PLAN OF PROPOSED SEPTIC SYSTEM

LOCUS: BROWN ROAD HAMPTON FALLS, N.H.

DATE: 2/1/90 * AMENDED 8/7/90 (SEE NOTE A)

APPROVAL: 180077

PLAN — 1" = 20'

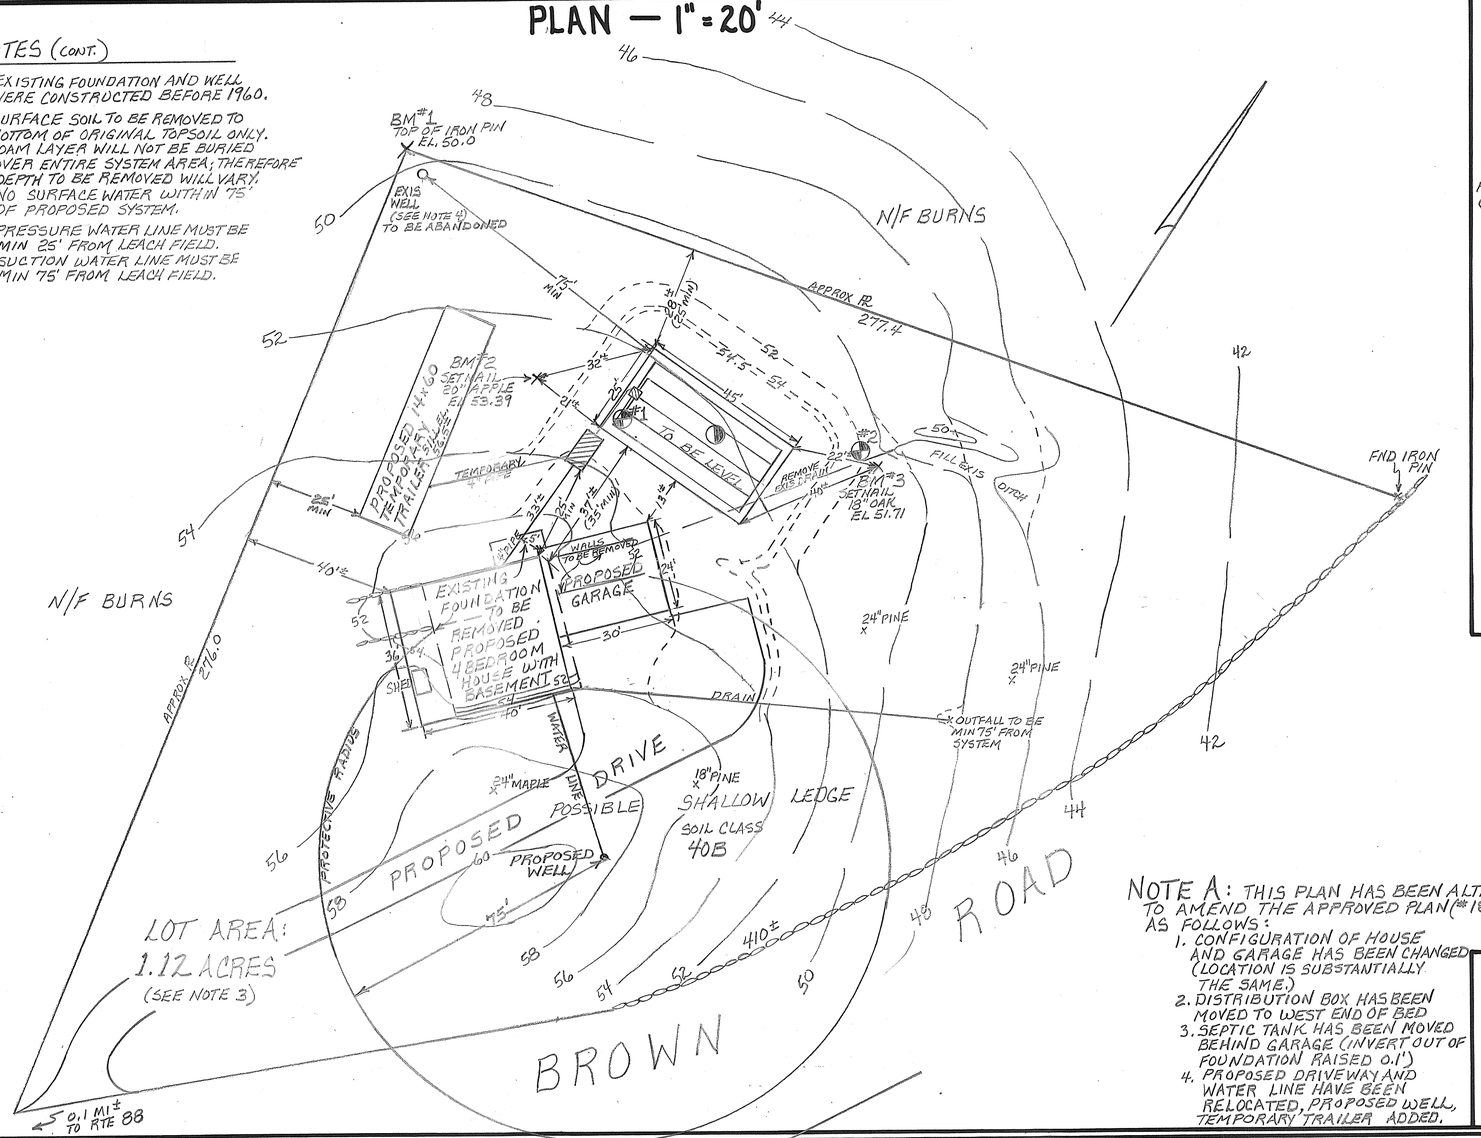
NOTE A: THIS PLAN HAS BEEN ALTERED TO AMEND THE APPROVED PLAN (#180077) AS FOLLOWS:
1. CONFIGURATION OF HOUSE AND GARAGE HAS BEEN CHANGED (LOCATION IS SUBSTANTIALLY THE SAME.)
2. DISTRIBUTION BOX HAS BEEN MOVED TO WEST END OF BED
3. SEPTIC TANK HAS BEEN MOVED BEHIND GARAGE (INVERT OUT OF FOUNDATION RAISED 0.1')
4. PROPOSED DRIVEWAY AND WATER LINE HAVE BEEN RELOCATED, PROPOSED WELL, TEMPORARY TRAILER ADDED.
